LEU, MRU

FSB 252-026, Two Piece Flex Pipe

(January 2012)

Two Piece Flex Pipe

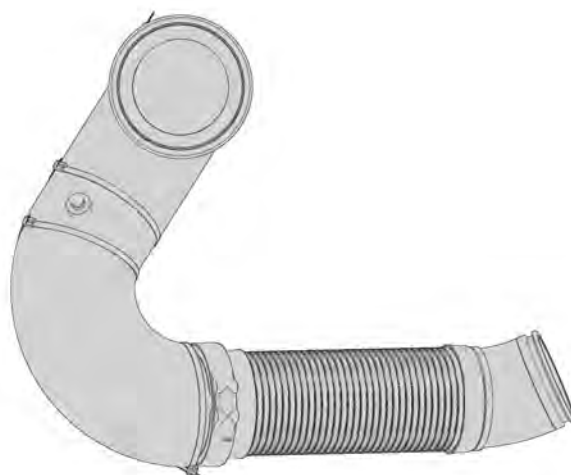
A new two piece flex pipe and diesel particulate filter (DPF) inlet pipe have been released to replace the current exhaust pipe. During the initial pipe replacement it will be necessary to replace both the inlet pipe and flex pipe along with a new clamp. After the initial replacement it will then be possible to replace the individual components.

On LEU models 21046556, 20856349, 20862730 replaced by 21765918, 21765923. On MRU models 21045279, 20856349, 20862730 replaced by 21765918, 21765920.
